Access Compliance Report

Public Rights-of-Way

(Curb Ramps)

Intersection ID: 30402	Main Street: WOODLAWN_RD	Cross Street: PARK_RD_SHOPPING_CENTER_DR	Location: NW
ADA ID: 306D6843A234	Ramp Type: Perp	Initial Pass/Fail: Fail	Overall Compliance: No
Severity Score: 12.5			
Codes/Mitigation Info/Possible Solution		Field Measurements/Component Compliance

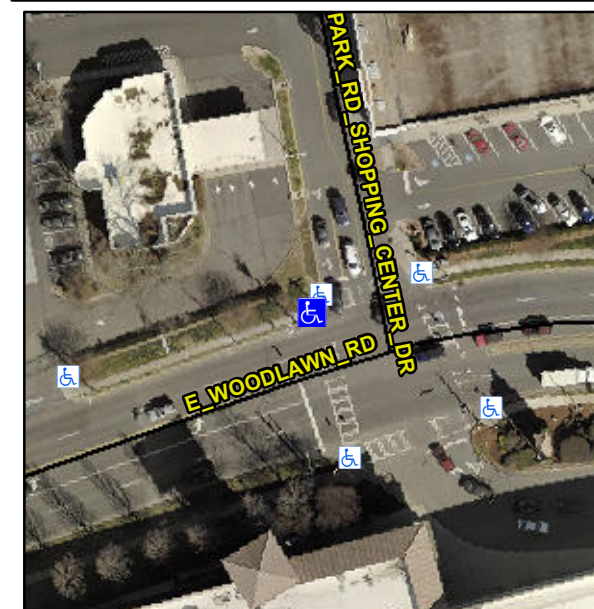
R304.2.2

Compliance	Description	Data	Compliance	Description	Data
N/A	Ramp Length (in)	24.0	No	Ramp Slope (%)	9.6
Yes	Ramp Width (in)	48.0	Yes	Ramp XSlope (%)	1.7
N/A	Flare Type LT	N/A	N/A	Flare Type RT	N/A
N/A	Flare Slope LT (%)	N/A	N/A	Flare Slope RT (%)	N/A
N/A	Flare Traversable LT?	N/A	N/A	Flare Traversable RT?	N/A
N/A	Landing Length (in)	N/A	N/A	DWS Provided?	N/A
N/A	Landing Width (in)	N/A	N/A	DWS Contrast?	N/A
N/A	Landing Slope (%)	N/A	N/A	DWS Length (in)	N/A
N/A	Landing X Slope (%)	N/A	N/A	DWS Full Width?	N/A
N/A	Landing Curb? (Y/N)	N/A	N/A	DWS Offset (in)	N/A
N/A	Shared Landing?	N/A			
N/A	Gutter Ponding?	N/A	N/A	Gutter Slope (%)	N/A
N/A	Gutter Lip Ht (in)	N/A	N/A	Gutter X Slope (%)	N/A
N/A	Painted X Walk1?	Yes	N/A	Painted X Walk2?	N/A
	X Walk 1 Direction	To S		X Walk 2 Direction	N/A
N/A	X Walk 1 Width (in)	101.0	N/A	X Walk 2 Width (in)	N/A
	X Walk 1 Slope (%)	2.3		X Walk 2 Slope (%)	N/A
	X Walk 1 X Slope (%)	3.2		X Walk 2 X Slope (%)	N/A

Remove & Replace Entire Ramp.
